# INSTRUCTION SHEET

## TOUCH PANEL INDICATOR LIGHTS AND BUTTON OPERATING PROCEDURES

**OLDER PANEL**

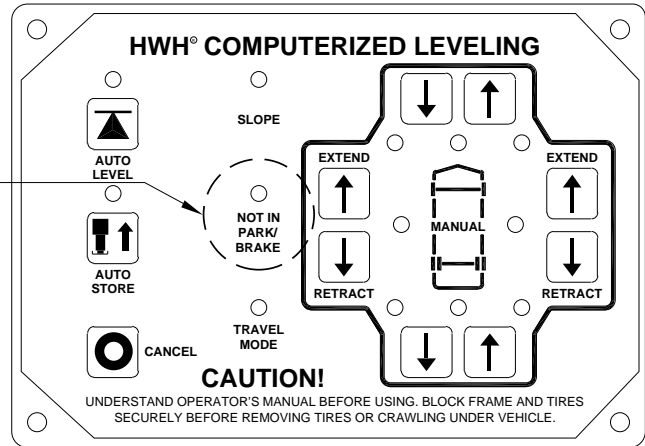
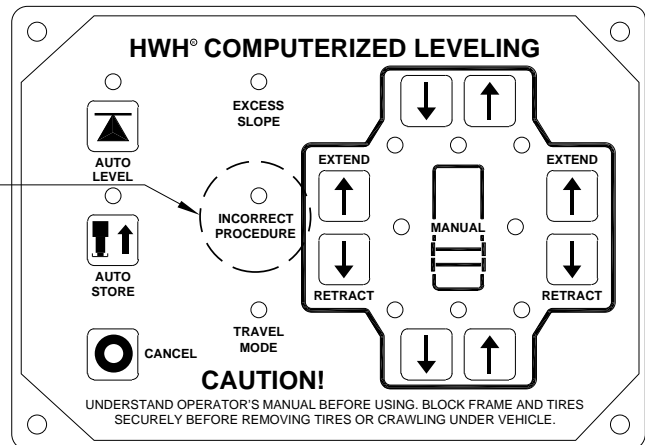
Check the existing touch panel. If the "INCORRECT PROCEDURE" light is labeled "NOT IN PARK/BRAKE" on the existing touch panel, it is important that the owner receives this sheet.

If the existing touch panel has a "NOT IN PARK/BRAKE" light, the existing control box being replaced may have a slightly different program.

The program in the replacement control box uses the "NOT IN PARK/BRAKE" LIGHT (older panel) or the "INCORRECT PROCEDURE" light (current panel) to indicate a procedure issue that will not allow the system to auto level or auto store the leveling system.

If the system is equipped with the older style touch panel it is NOT necessary to change the touch panel, but if desired, a new lexan can be ordered. The part number for the new lexan is RP92639. To replace the lexan, simply use a small knife to peel the old lexan off of the touch panel. Remove the protective back from the new lexan and press the new lexan in place.
